SERVICE CAMPAIGN BULLETIN

CAMPAIGN REF : 008
TITLE : Door latch replacement
DOCUMENT # : 11 A 011

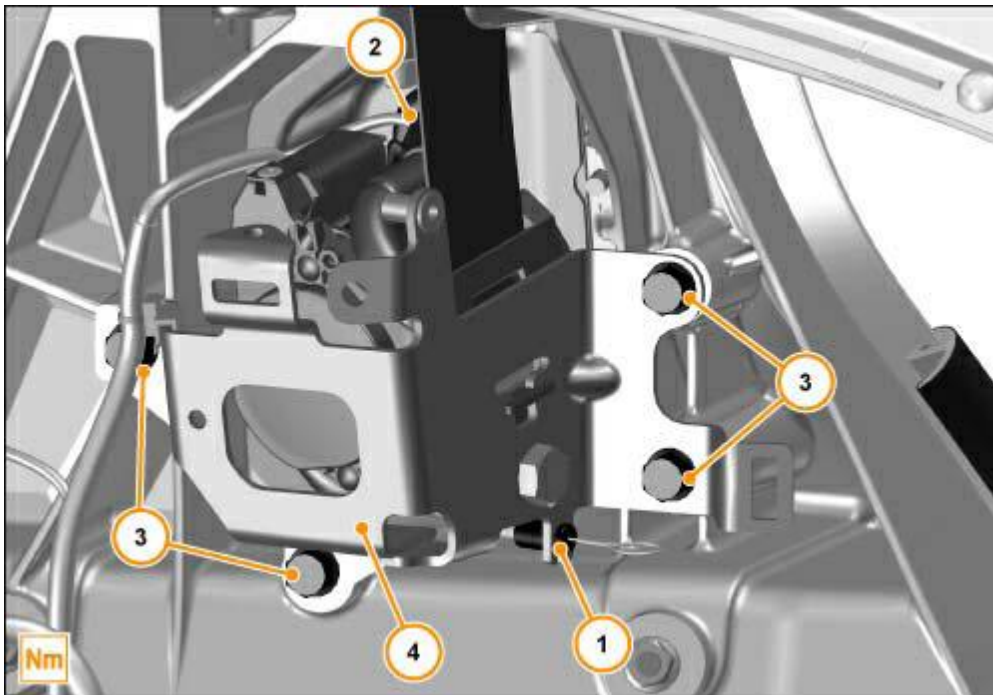
SITUATION : Quality Engineering at McLaren Automotive have identified that the existing door latches are susceptible to water ingress and therefore at significant risk of failure.

PROCEDURE : Replace both door latches on all affected vehicles

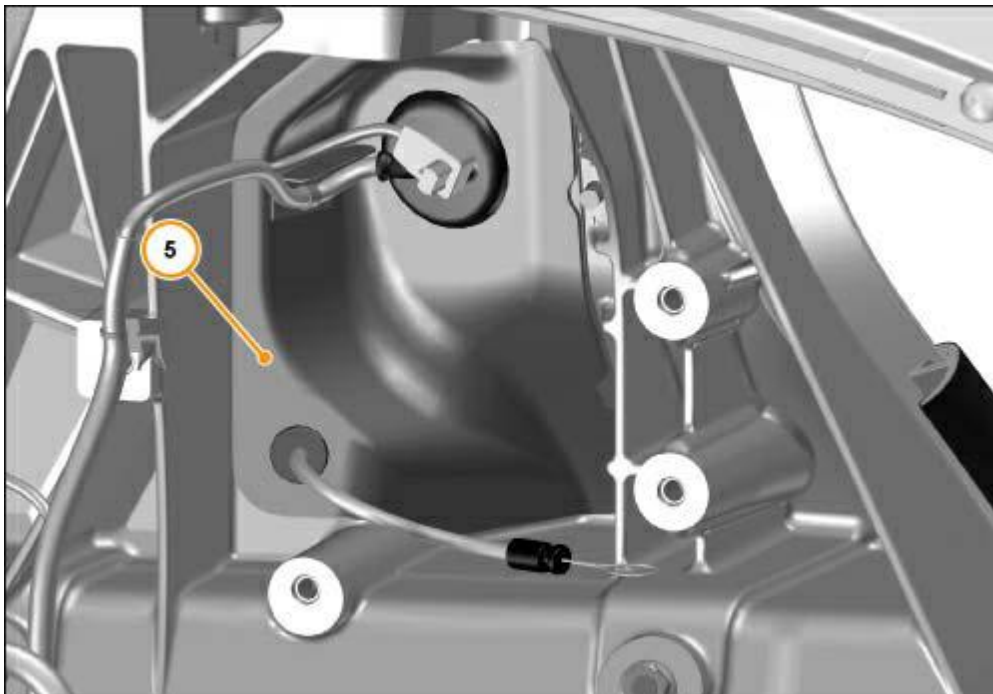
3. Please refer to A-RM-06N06-01-008 - Remove/Install B-Pillar finisher.
4. Detach release cable (1) from bracket.
5. Disconnect electrical connector (2).
6. Remove bolts (3). M8 x 16 26 Nm.
7. Remove bracket (4) partially with seat belt and move clear of area.

Care Point: Detach the manual release cable and wiring harness grommets from the B-pillar latch access cover before removing the cover.

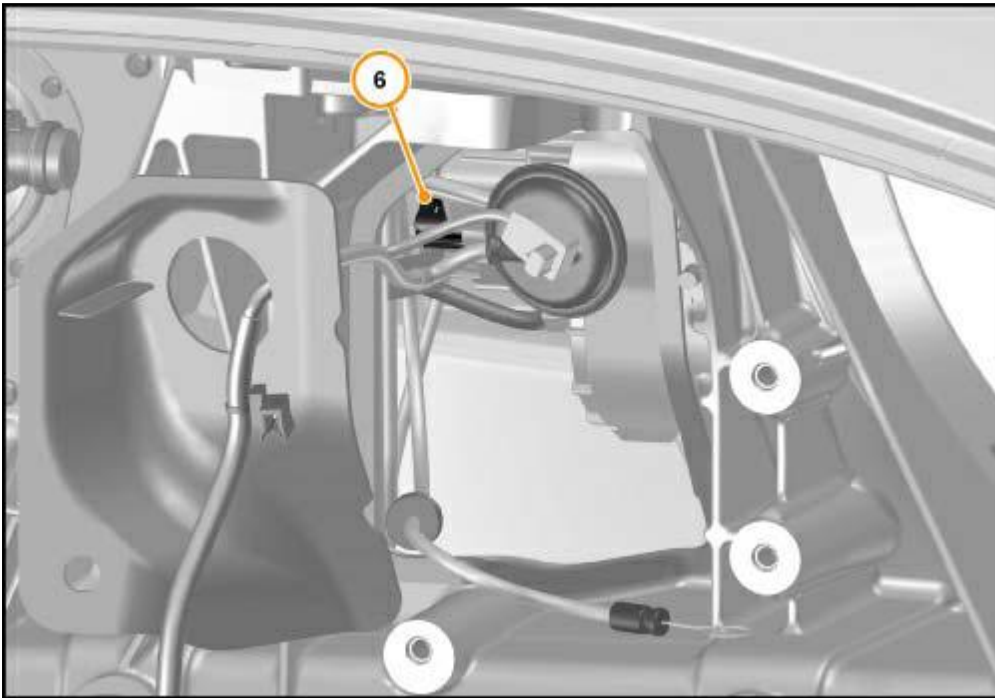
8. Remove B-pillar latch access cover (5).

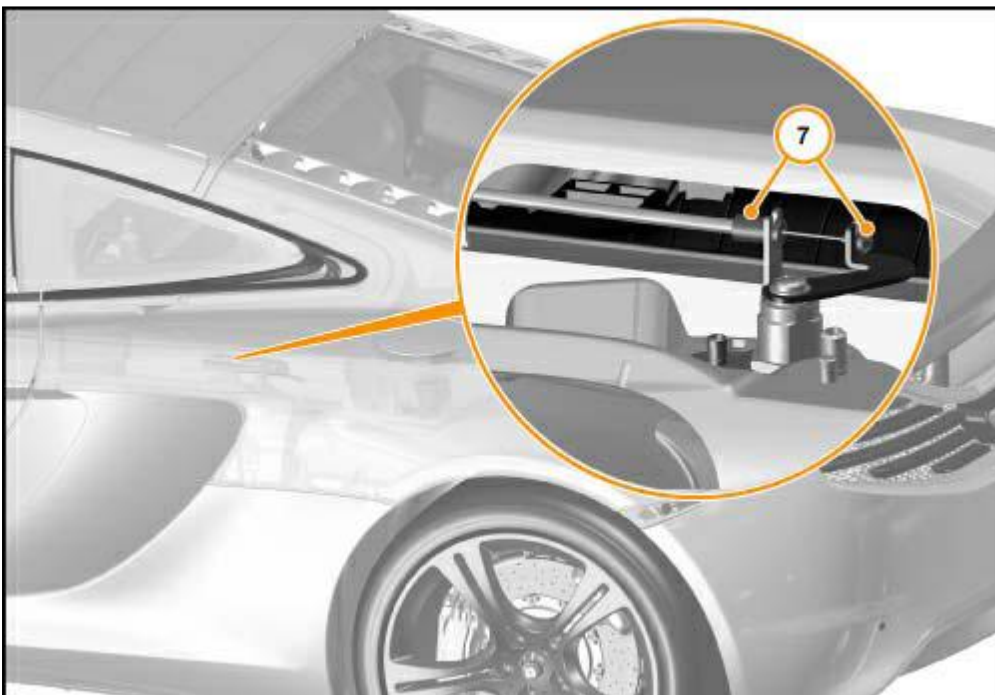
9. Disconnect electrical connector (6).

Care Point: Only remove the release cable from the key barrel if replacing the left hand door latch. Left hand side engine bay panel would have to be removed to gain access to the release cable.

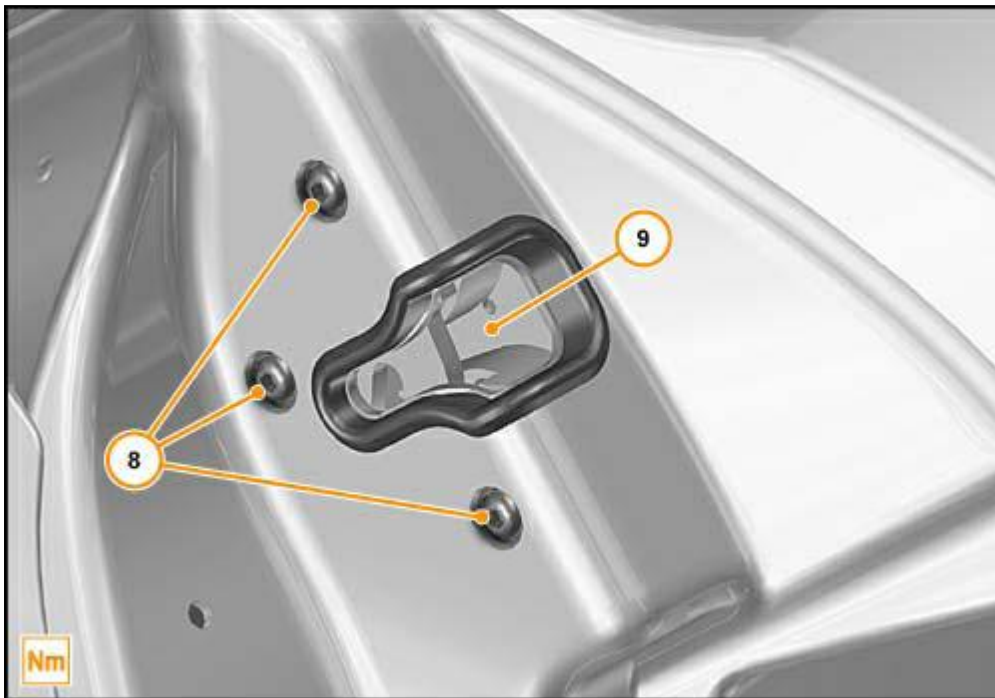
10. Remove release cable (7) from key barrel using a small angular lever bar.

11. Remove bolts (8). M6 x 10 8 Nm

12. Remove door latch (9).

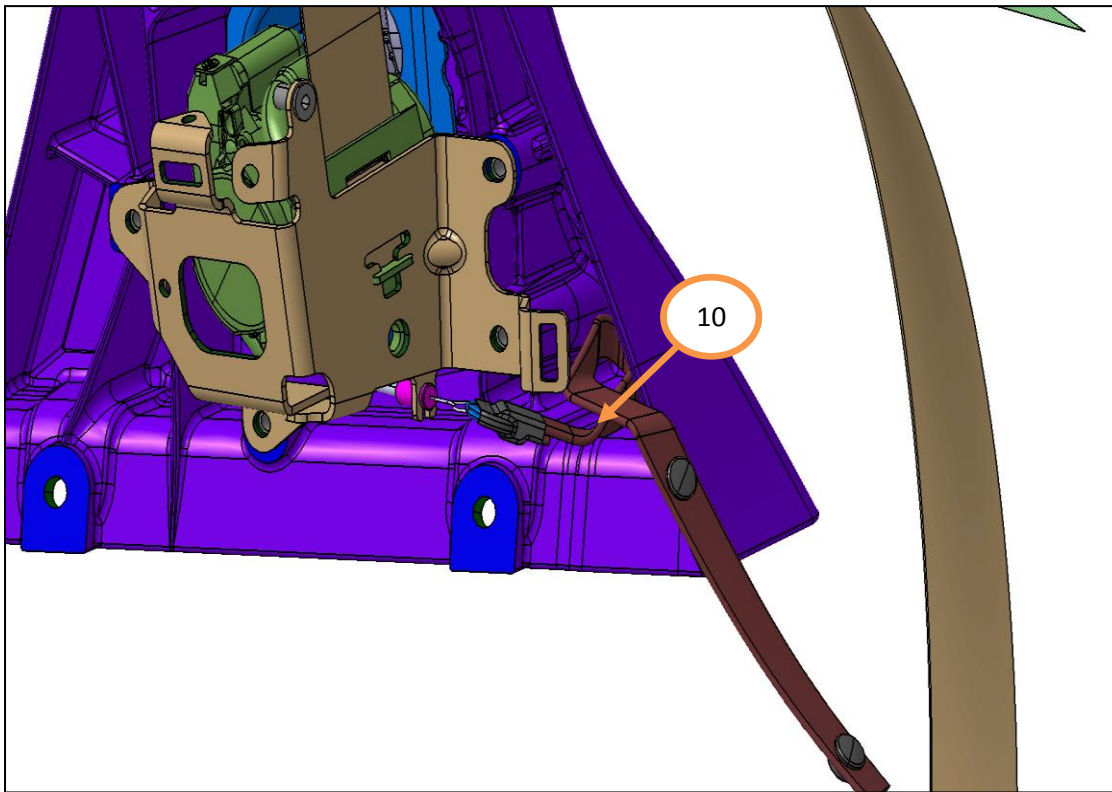
Care point: to refit release cable we recommend the use of long nose pliers to insert the end of the cable on the movable bracket. Use a small angular lever bar to press down the rubber grommet into the fix bracket

Care point: Remove excess sealant from B-pillar latch access cover.

Care point: Re-apply sealant Scotch-Weld 750c to the B-Pillar latch access cover. Allow 12 hours bonding time and fix securely in place to prevent the access cover sagging during cure.

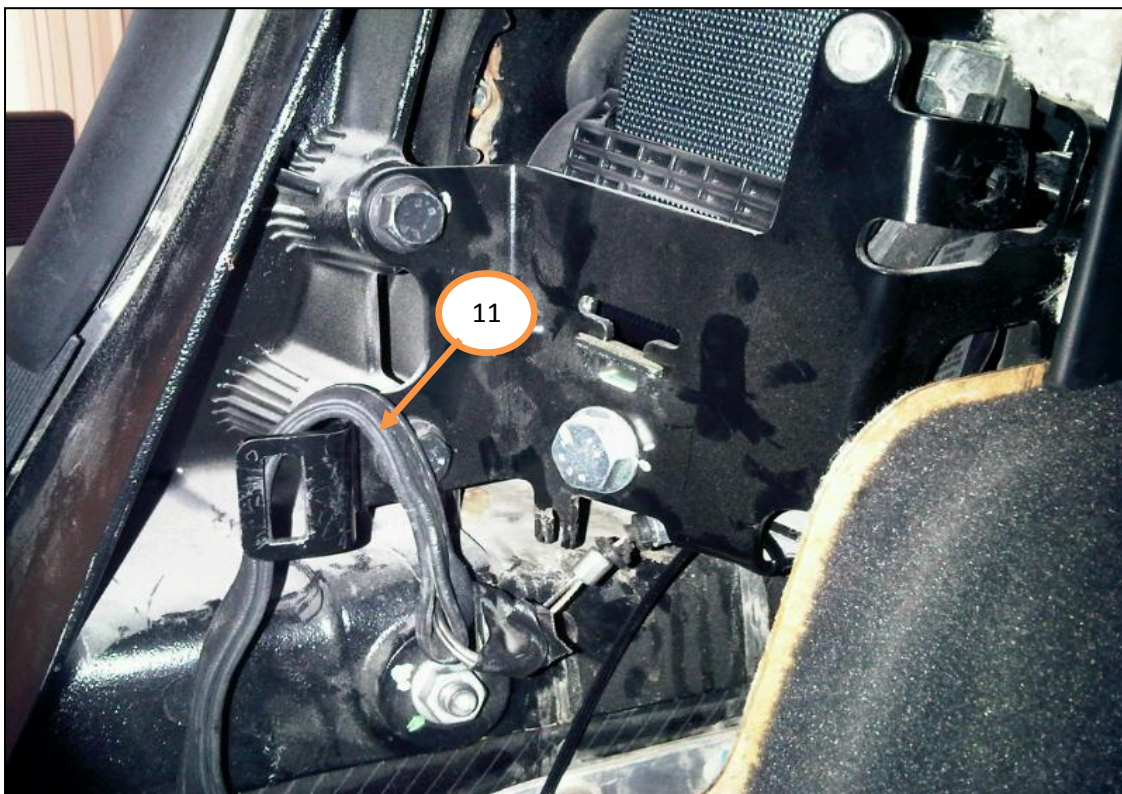
Care point: It is **vital** that the manual door release leather strap is routed underneath the B-Pillar fixing bracket. Below is an example of the correct routing (10):

Below is an example of the incorrect routing (11).
